RE: HADLOCK PLASTICS
3GR00243*DG
STORMWATER
ASHTABULA COUNTY

On June 28, 2010, this writer conducted an inspection of your facility located at 110 North Eagle Street in Geneva, Ohio to determine compliance with your Industrial General Storm Water NPDES permit referenced above. Along with my observations from the inspection, I have provided comments concerning your permit below:

Figure 1: Fluids from the drum storage area leaking into the storm sewer.

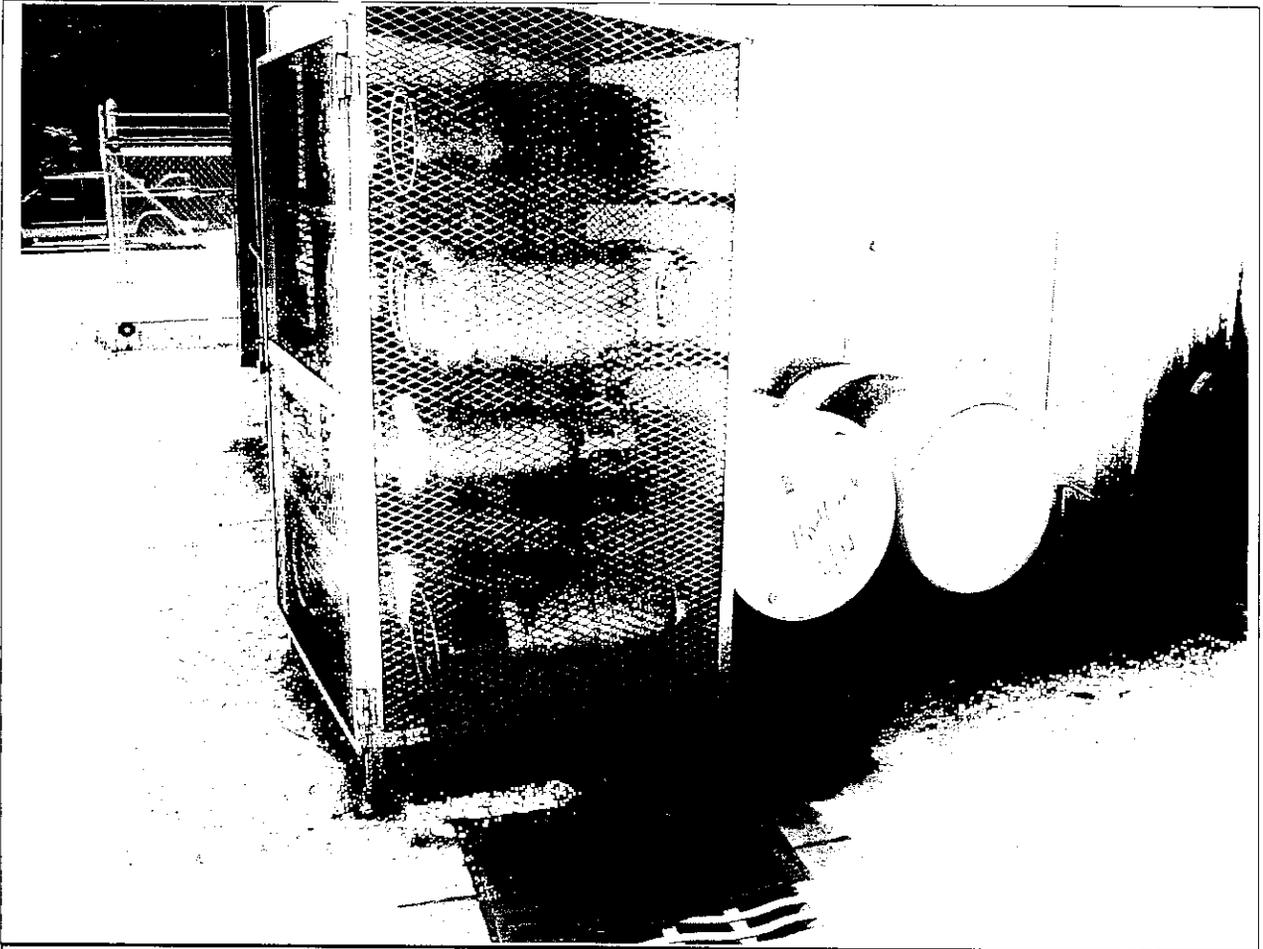
1. While walking around the outside of the building I noticed a few areas of concern. Fluids were leaking from the drum storage area into the nearby storm sewer. The drums stored outside should be moved inside or into secondary containment with a cover to prevent chemicals from entering storm sewers. If possible, all drums should be moved away from storm drains. Figure 1 shows the fluid draining into the storm sewer.
2. There was a sheen on the water in the catch basin near the drum storage area. Regular monitoring should be conducted to ensure that no chemicals are entering the storm drains.
3. One of the dust collectors had powder on the ground around it. These spills should be swept up as soon as they occur.

- Store all barrels inside or in secondary containment with a cover to prevent residual chemicals from discharging into the storm sewer.
- Monitor the storm sewer near the drum storage for a sheen.
- Sweep up powder around the dust collector.
- Create an SWPPP.
